SUBJECT: AMENDMENT NO.128 TO FACILITY OPERATING LICENSE NO. DPR-43 -  
 KEWAUNEE NUCLEAR POWER PLANT (TAC NO. M95302)

The amendment revises KNPP TS 4.2.b, "Steam Generator Tubes," its associated bases, and Figure TS 4.2-1 by redefining the pressure boundary for Westinghouse mechanical hybrid expansion joint (HEJ) steam generator (SG) tube sleeves.

AMENDMENT TO FACILITY OPERATING LICENSE

SAFETY EVALUATION BY THE OFFICE OF NUCLEAR REACTOR REGULATION  
RELATING TO AMENDMENT NO. 128 TO FACILITY OPERATING LICENSE NO. DPR-43

Application of Plugging Limit for a Westinghouse Mechanical Sleeve

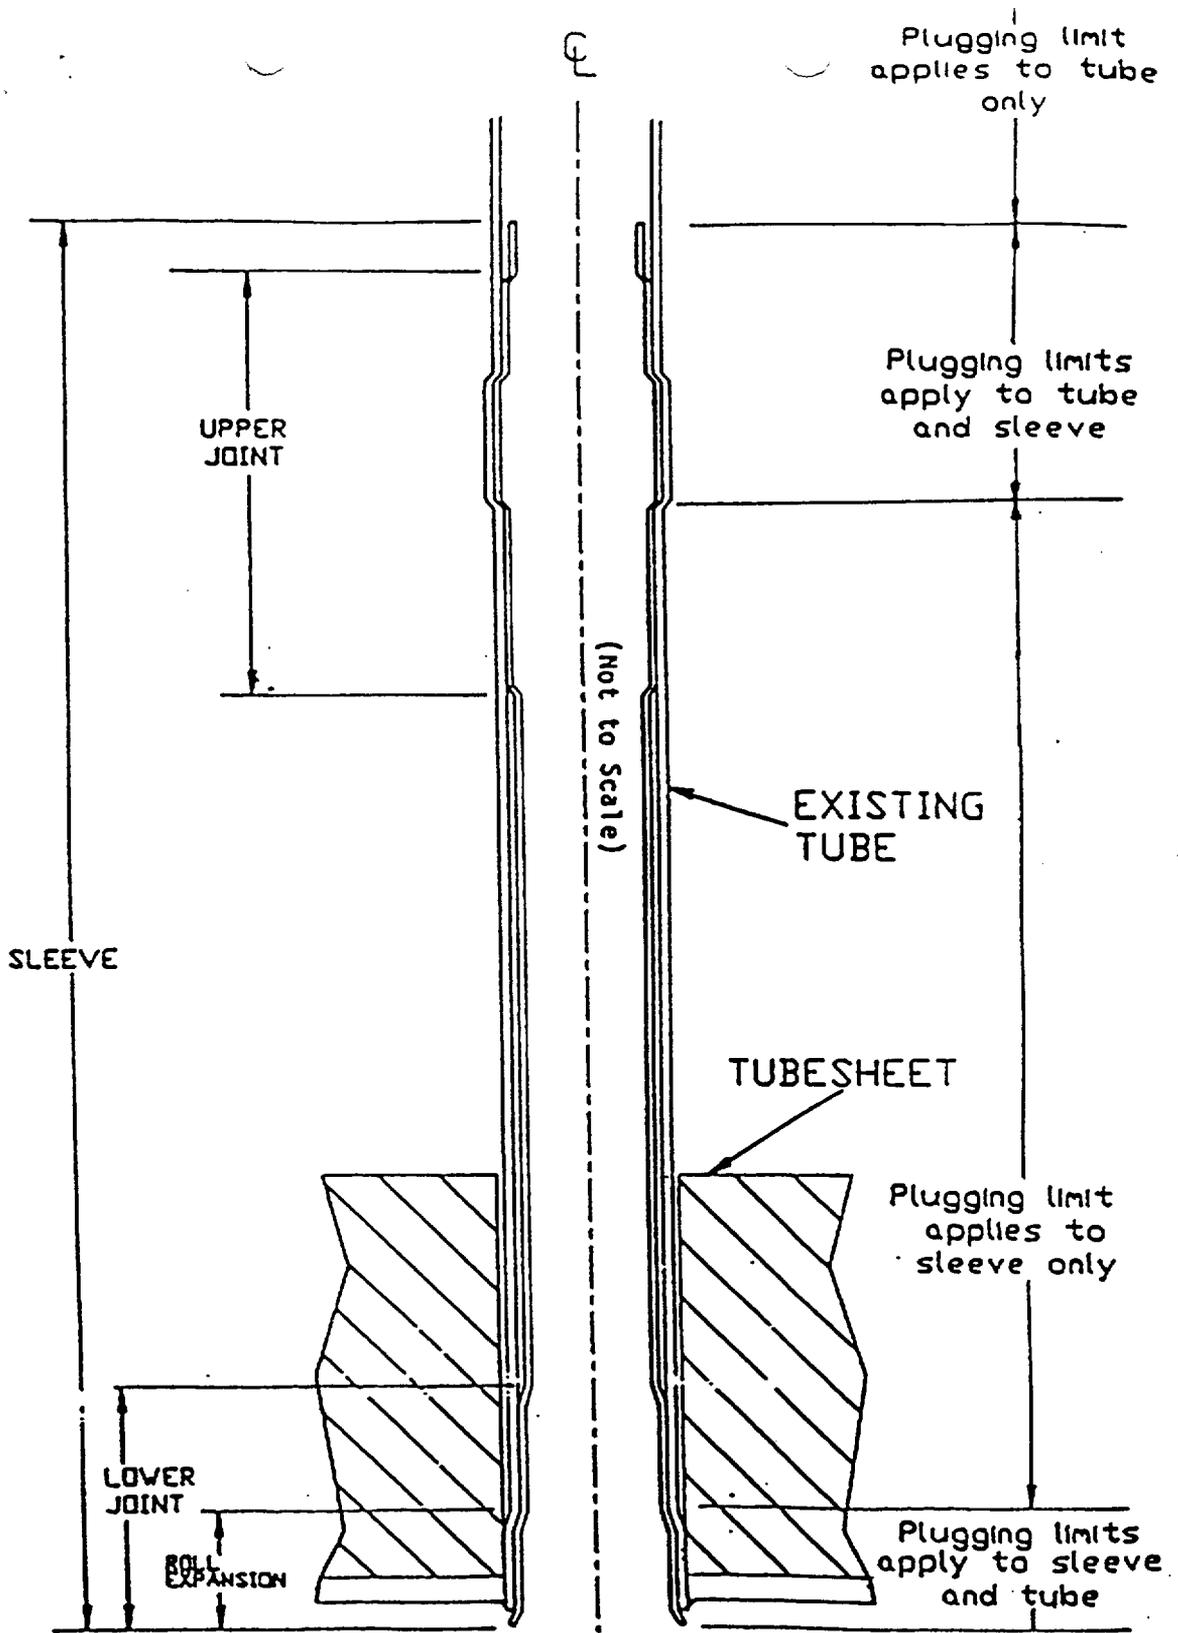
3. HEJ sleeved tubes with axial indications located within the parent tube pressure boundary as defined on Figure TS 4.2-1 shall be plugged or repaired prior to returning the steam generator to service.

4. HEJ sleeved tubes with parent tube indications located outside of the parent tube pressure boundary as defined on Figure TS 4.2-1 may remain in service.

Figure TS 4.2-1 would be revised to reflect the revised boundaries for determining whether the plugging limit applies to the tube only, to the tube and sleeve, or to the sleeve only.

For the Westinghouse mechanical sleeves, the sleeve plugging limit of 31% is applied to the sleeve as shown on Figure TS 4.2-1. For the Combustion Engineering leak tight sleeves, a plugging limit of 40% is applied to the sleeve and weld region. The sleeve plugging limits allow for eddy current testing inaccuracies and continued operational degradation per Draft Regulatory Guide 1.121 (August 1976).

The pressure boundary for HEJ sleeves is shown on Figure TS 4.2-1. The pressure boundary used to disposition parent tube indications (PTIs) detected in the upper joint of HEJ sleeved tubes is discussed in WCAP-14641<sup>(6)</sup>. The pressure boundary will allow PTIs located such that there is a minimum diameter change of 0.003 inch (plus an allowance for NDE uncertainty) between the peak diameter of the sleeve hardroll, and the diameter at the elevation of the PTI, to remain in service. The 0.003 inch interference lip is derived from structural and leakage testing. When inspecting and dispositioning the PTIs, the acceptance criteria will be adjusted to account for measurement uncertainties associated with the technique used to measure the relative change in ID sleeve diameters. During field application, the PTI elevation will be measured by comparing the diameter reported at the peak amplitude of the flaw, and the diameter at the center of the plus point coil's field, and using the more conservative of the two diameters to perform the  $\Delta D$  determination. Application of the pressure boundary for HEJ sleeved tubes provides allowance for leakage in a faulted loop during a postulated steam line break (SLB) event. A SLB leakage of 0.025 gpm is assumed for each applicable indication. Steam line break leakage from all sources must be calculated to be < 34 gpm in the faulted loop. Maintenance of the 34 gpm limit ensures off-site doses will remain within a small fraction of the 10 CFR Part 100 guidelines for a SLB.

The staff has reviewed the TS changes discussed above and finds that they consistently incorporate the methodology for relocating the pressure boundary for HEJ sleeves as previously discussed in this safety evaluation and will provide adequate assurance of SG tube integrity. Therefore, the proposed changes are acceptable.
